Re: Transportation Impact Study – Reliance Letter

Plan of Subdivision/Common Element Condominium Applications

231-245 Reach Street, Township of Uxbridge

Transportation Impact Study Addendum

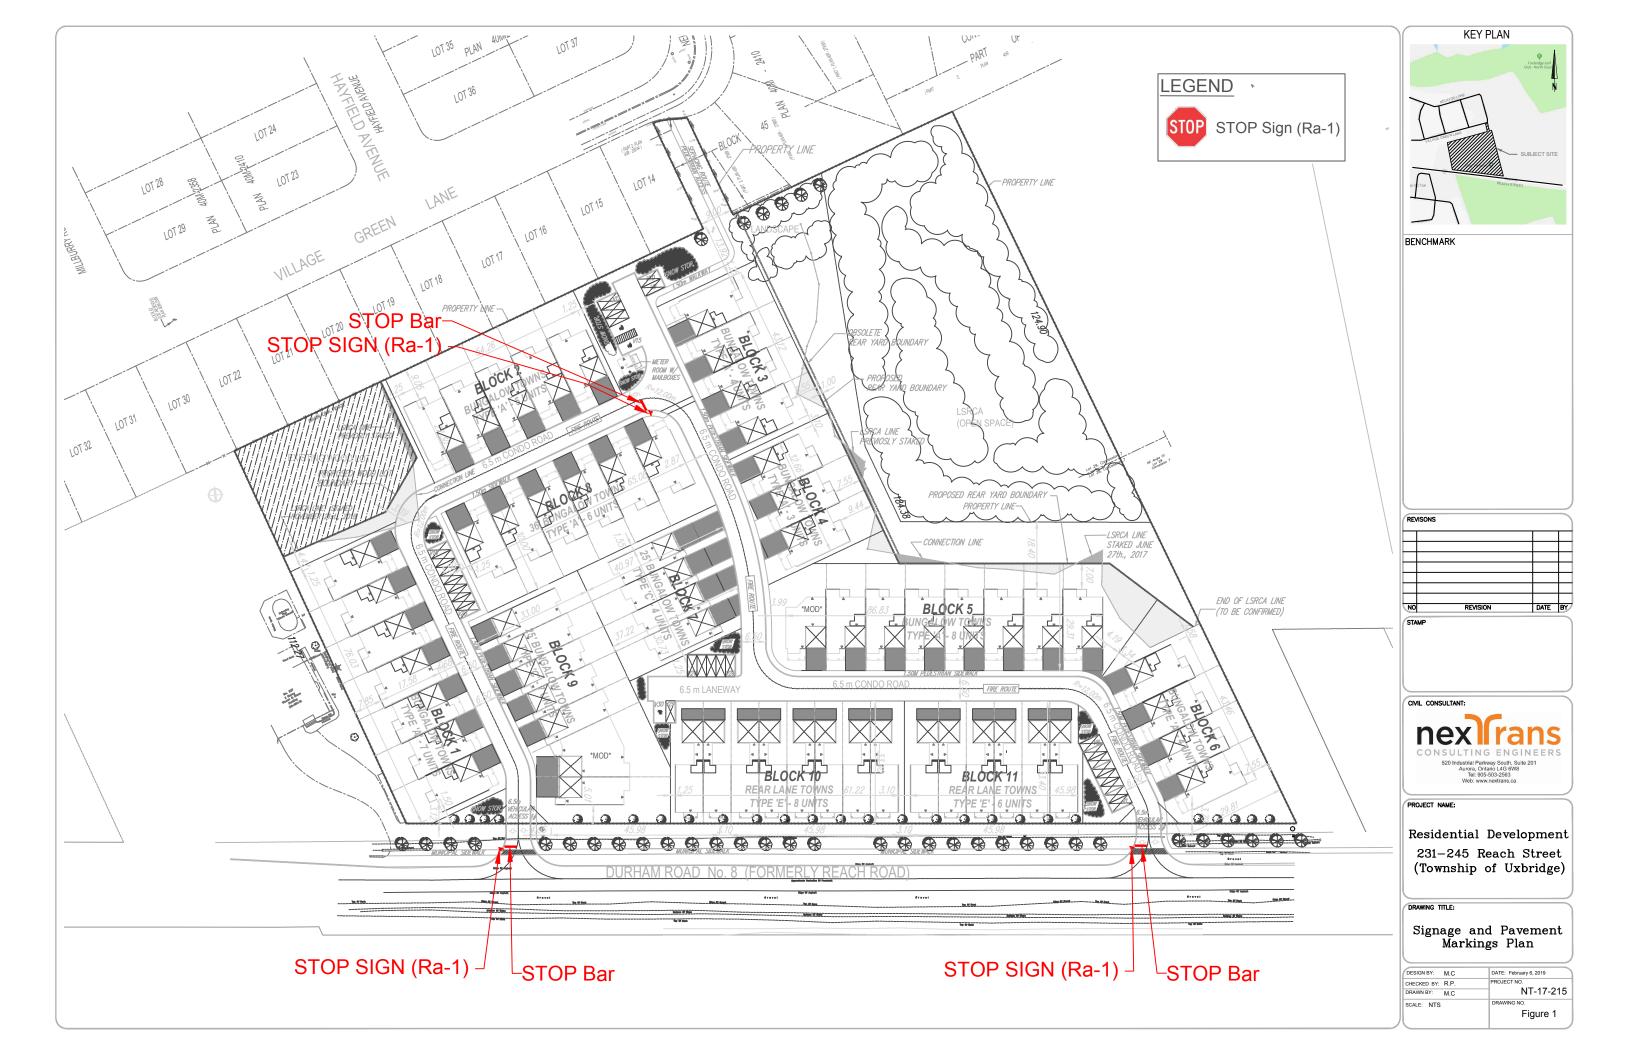
Based on the revised plan, the signage and pavement marking plan was updated, see **Figure 1**, and AutoTURN software was used to confirm the maneuvering of a Garbage/Emergency vehicle (HSU TAC-2017) throughout the site, see **Figure 2**.
